# UNITED STATES PATENT AND TRADEMARK OFFICE

APPLICATION NO.	FILING DATE	FIRST NAMED INVENTOR	ATTORNEY DOCKET NO.	CONFIRMATION NO.
10/789,870	02/26/2004	Tadashi Maegawa	P/1250-272	3619

## Office Action Summary

Fig. 2

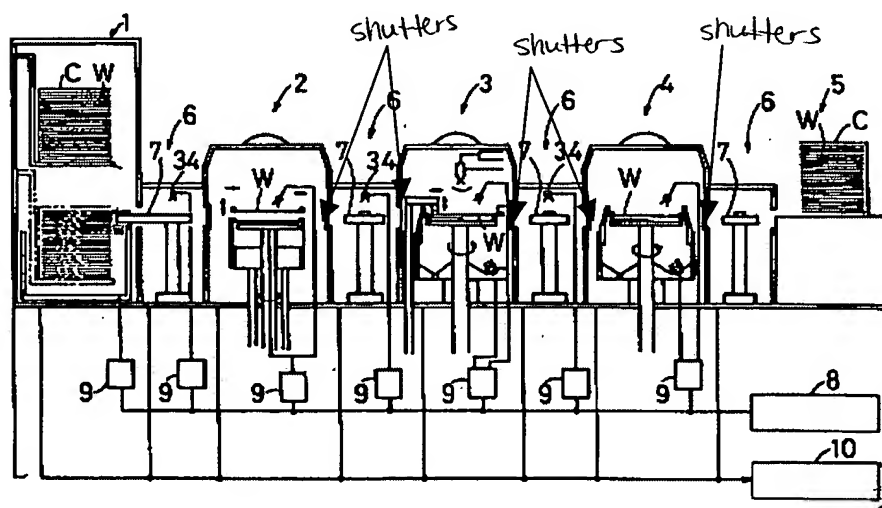
The examiner has inserted a copy of Figure 2 of Shinbara to mark her interpretation of a shutter or door to isolate the atmospheres between the chambers.

a liquid chemical processing chamber including said liquid chemical processing part: and a transport chamber 20 provided with said third opening, said transport chamber allowing transportation of substrates by said second transport mechanism, and wherein atmospheres in said liquid chemical processing chamber and said transport chamber can be isolated from each other via the partition plate shown in Fig. 2.
